UNITED STATES PATENT AND TRADEMARK OFFICE

APPLICATION NO.	FILING DATE	FIRST NAMED INVENTOR	ATTORNEY DOCKET NO.	CONFIRMATION NO.
08/936,510	09/24/1997	YONG BEOM KIM	8733.20056	9825
30827	7590	05/10/2004		
MCKENNA LONG & ALDRIDGE LLP 1900 K STREET, NW WASHINGTON, DC 20006			EXAMINER CHOWDHURY, TARIFUR RASHID	
			ART UNIT 2871	PAPER NUMBER

Office Action Summary

DETAILED ACTION

FIG. 1

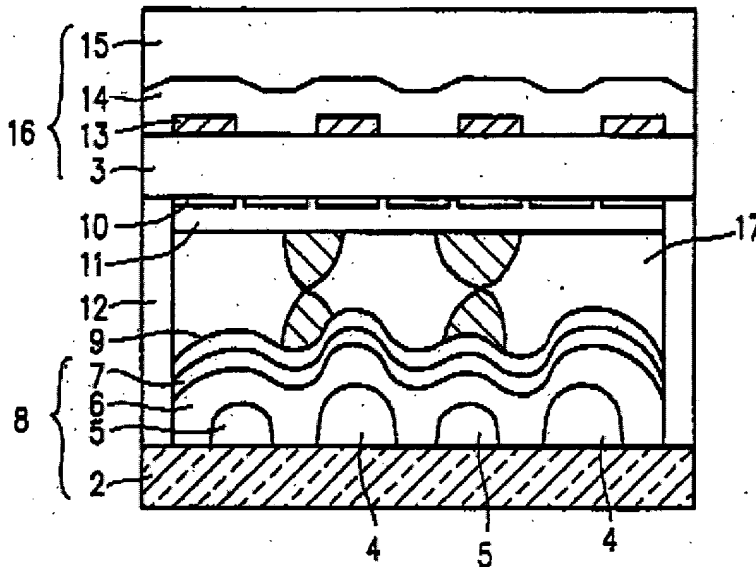
3. Mitsui discloses and shows in Fig. 1, a reflection-type liquid crystal display device, comprising:

- first (2) and second (3) substrates;
- a reflective electrode (7) over the first substrate (2), wherein the reflective electrode comprises metal such as aluminum, chromium etc. (applicant's opaque metal) (col. 5, lines 59-62);
- a liquid crystal layer (17) disposed interjacent the first and second substrates;
- two uniaxial optical compensation films (13,14) (col. 6, lines 11-13) of a same type (col. 10, lines 58-63; col. 12, lines 14-23) over the second substrate (3);
and
- a first alignment layer (9) over the first substrate (2) (col. 6, lines 28-29).

Accordingly, claim 1 is anticipated.

As to claim 14, since the method of manufacturing the device is merely a list of forming each component and each component must be formed to make the device, the method of manufacturing would be inherent to the device.
